December 13, 1982

Subject: Dresden 2
SEP Topic IX-5, Ventilation Systems

NRC Docket 50-237

FIG. 1
 TYPICAL AMP-HOUR RECHARGE CURVE
 250 VOLT BATTERY (FPS-25, 996 A-HR, 120 CELLS)
 100 AMP, 260 VOLT CONSTANT VOLTAGE CHARGER

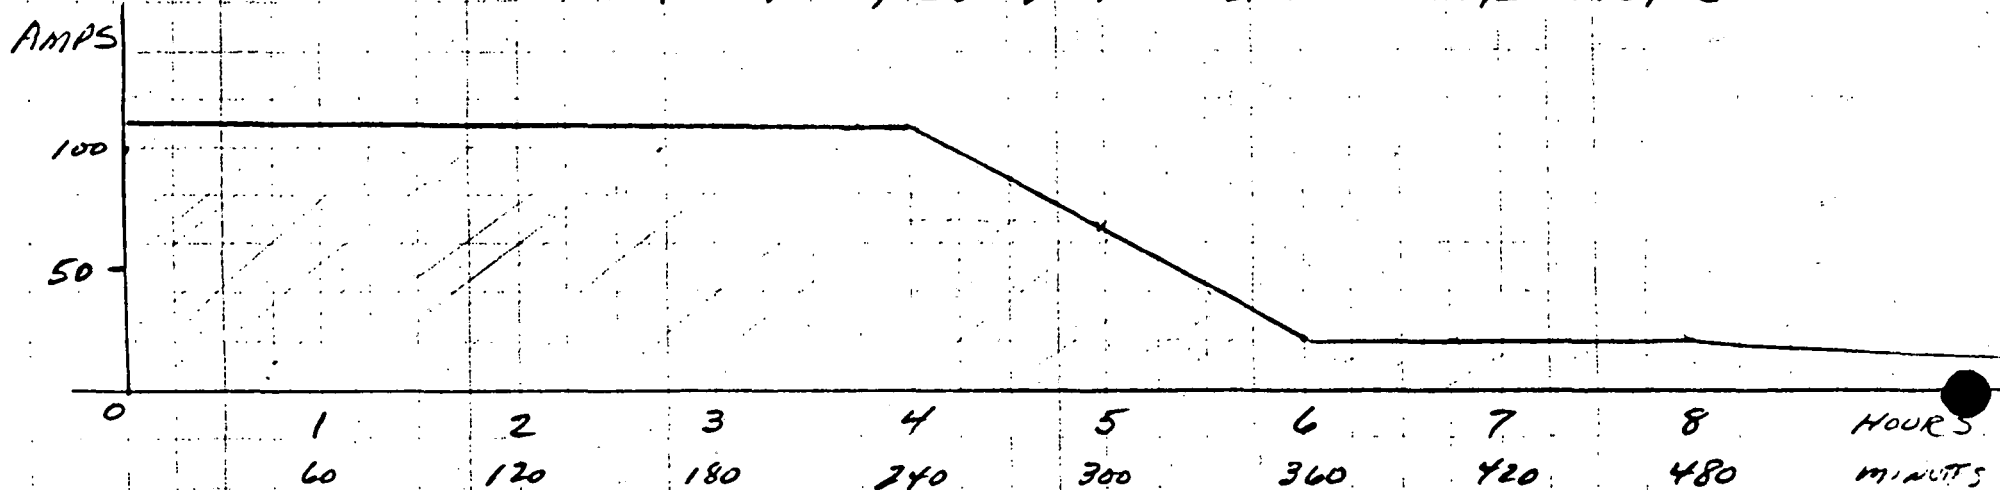
Item 1: Following a loss-offsite-power event, operator action is required to reinitiate the battery room ventilation system. During that inoperative period, hydrogen is generated because of continued battery charging. It is the staff's position that Commonwealth Edison should define the maximum period the ventilation system could be inoperative and demonstrate that of hydrogen generated during that period, will not exceed the minimum combustion limits or provide for adequate ventilation to preclude the potential for buildup of combustible hydrogen.

Response: The Unit 2 battery room ventilation system is not powered from an onsite source. The staff is concerned because the time of highest hydrogen concentration occurs while the diesel generator is being used to recharge the batteries. An evaluation was made to determine the amount of hydrogen generated during a recharge of the Dresden Unit 2 batteries and in that period will not exceed the minimum combustible limits. Attachment A provides technical information and equipment data. Figures 1, 2 and 3 provide battery recharge curves.

Figure 1, 2 and 3 illustrates a typical amp-hour recharge curves for a 250V, 125V and 24/48V battery respectively. For conservatism 5% of all charging is considered hydrogen generation. Based on 5% charging current rate, 2% hydrogen evolution rate, and zero natural ventilation the minimum volume of air space required for ventilation is as follows:
